**Brisbane Central Business District Bicycle User Group
CBD BUG**

**Brisbane Central Business District Bicycle User Group (CBD BUG) response on
Brisbane City Council Mary Street Vision**

This submission provides the Brisbane CBD BUG's views in response to the Brisbane City Council (BCC) Mary Street Vision, publicly released on 28 September 2022.

Figure 1: AustRoads Guide to Road Design Part 6A

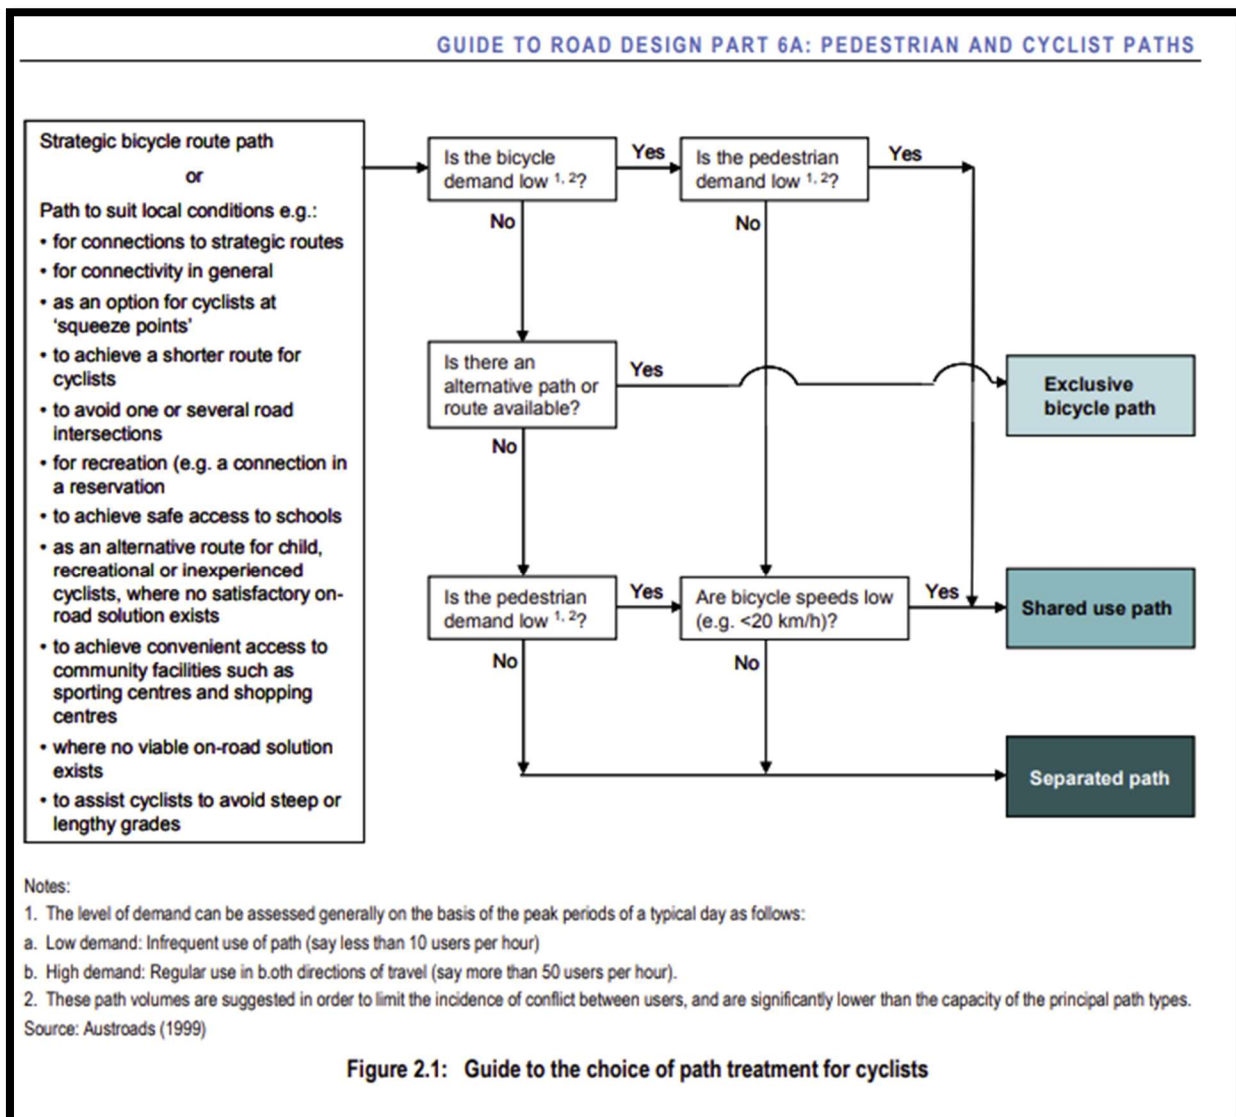
This will guarantee people travelling on bikes and scooters weaving between people walking, leading to conflict and the inevitable complaints about “near misses”, and then calls for people on two wheels to be banned from riding on the Mary Street footpath. The fact that BCC describes sections of Mary Street experiencing “high-volume pedestrian movements” makes this need for separation between people riding bicycles and scooters even more important. It would also suggest that BCC is failing to reference suitable planning guidelines such as AustRoads Part 6 (refer to Figure 1 on page 3 of this letter)
